II. AMENDMENTS TO THE DRAWINGS

Certificate of facsimile filing
on March 3, 2005 by Floyd E. Ivey,
Serial No. 10/647,030.

Application No. 10/647,030

Fig. 6

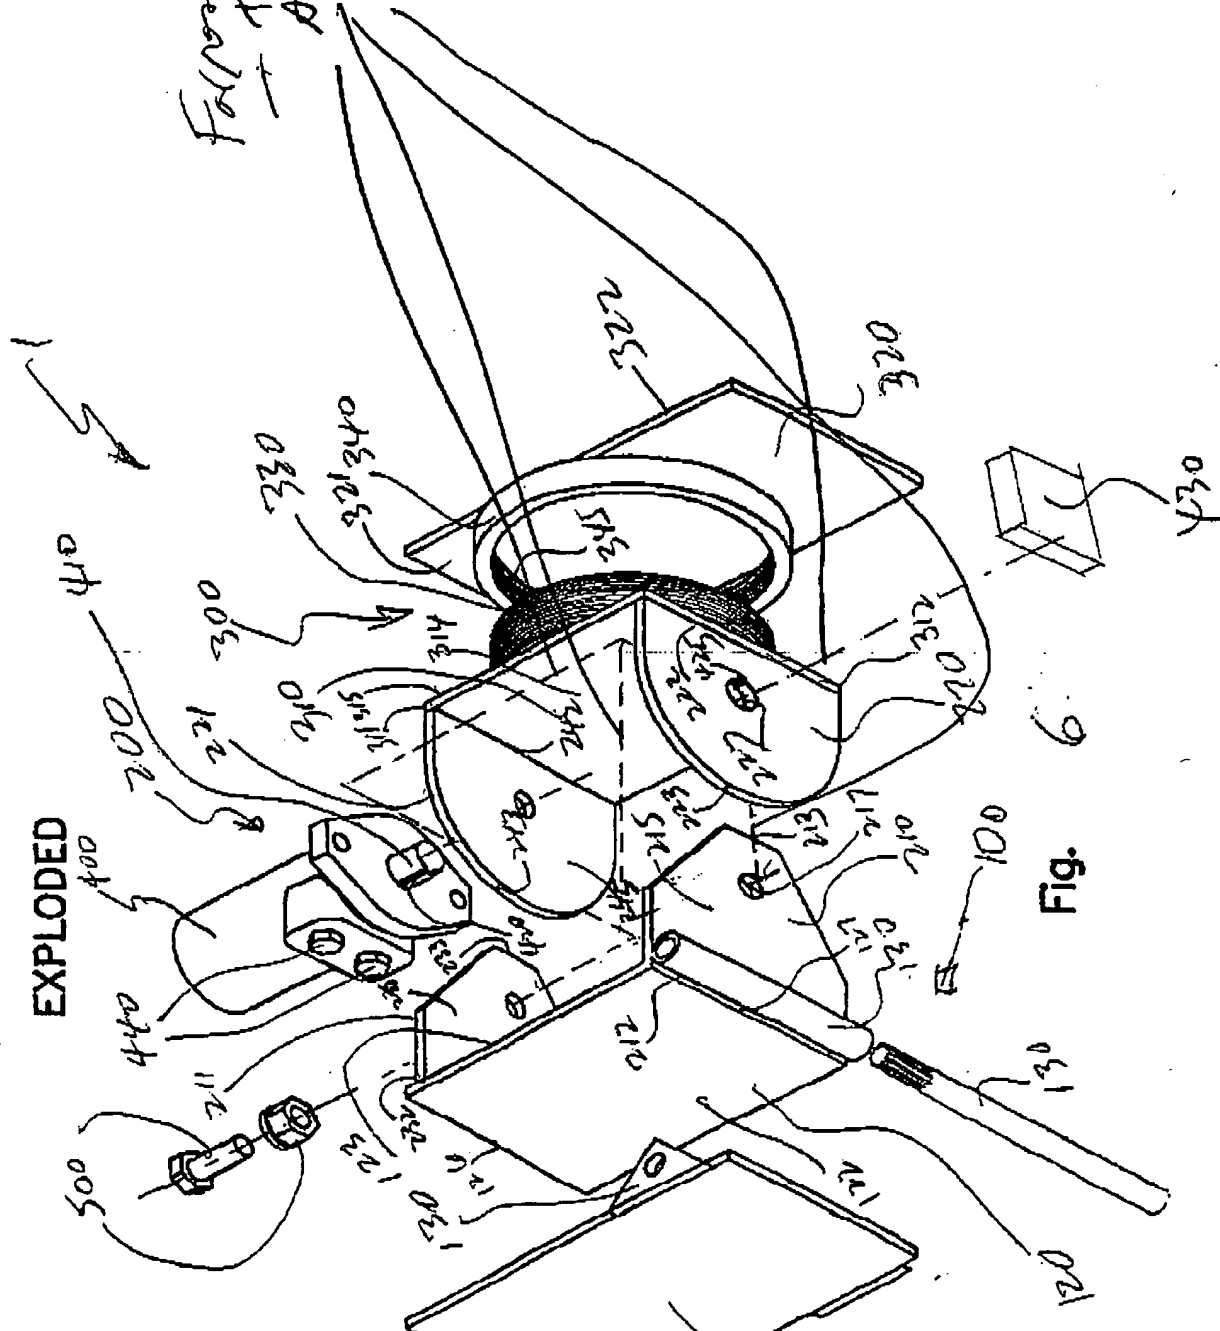
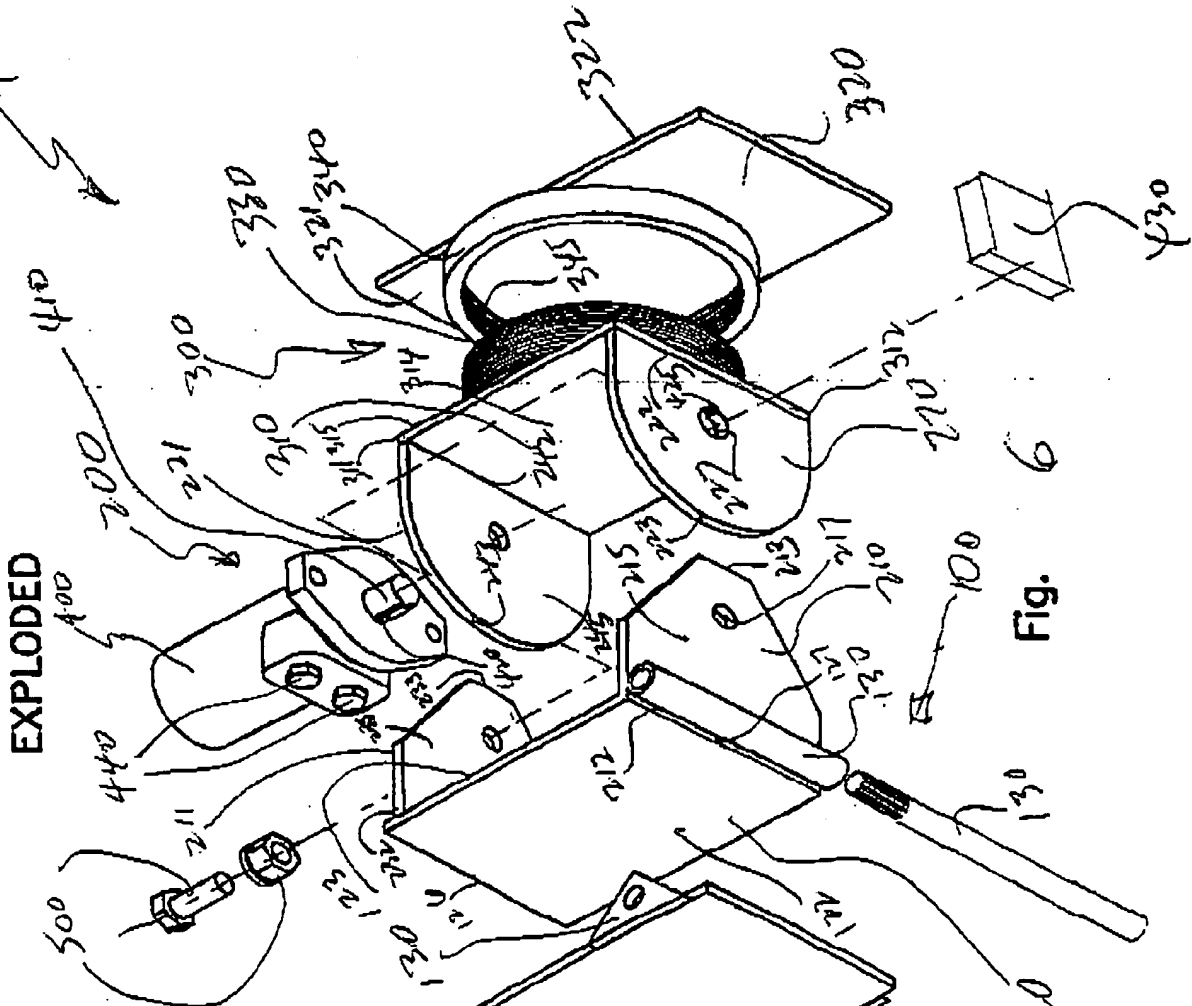
The Examiner states at page 3, paragraph 2 that the drawings of 10/4/04 are not approved because it is nuclear what changes have been made and that they do not overcome the objection set forth at page 3, paragraph 3 re: the substituted "figure shows modified forms of the drive means because it shows both the gear means 430, and the key/notch 420/425." and that these structures are mutually exclusive drive means.

For response 3/3/05.
The dashed line
shows the displaced
from the
Immediately
preceding fig. 6.

The identical drawings for Fig. 6, as submitted on 10/4/04, are again submitted with direction respectfully provided by line and note. The Examiner will see in the "Replacement Sheet 10/4/04" the dashed line indicating that the motor is affixed between the two sets of plates with the shaft engaging only apertures (217) and (227).

Regarding the matter of notch v. gear, your applicant respectfully submits that matter of the motor (400) being immovably affixed to one plate (215) and either notch/key or gear related to a second plate (220) will be obvious to one of ordinary skill. Your applicant is agreeable to submitting an additional drawing as Fig. 6A showing the gear removed but respectfully submits that such will require the additional drafting time in amendment of the specification. Your applicant submits that those of ordinary skill will appreciate the drawings as illustrating options.

Your applicant respectfully requests the Examiner to accept Fig. 6 as amended and as submitted in the prior paper and to withdraw the objection and allow the application to be prosecuted on the merits. Your applicant observes that the Examiner states at page 4 that "If changes are not accepted by the examiner, the applicant will be notified and informed of any required corrective action in the next Office action. The objection to the drawings will not be held in abeyance." Your applicant is uncertain of the meaning of these statements and requests the Examiner to consider the requests of the applicant and to advise if additional changes are required.
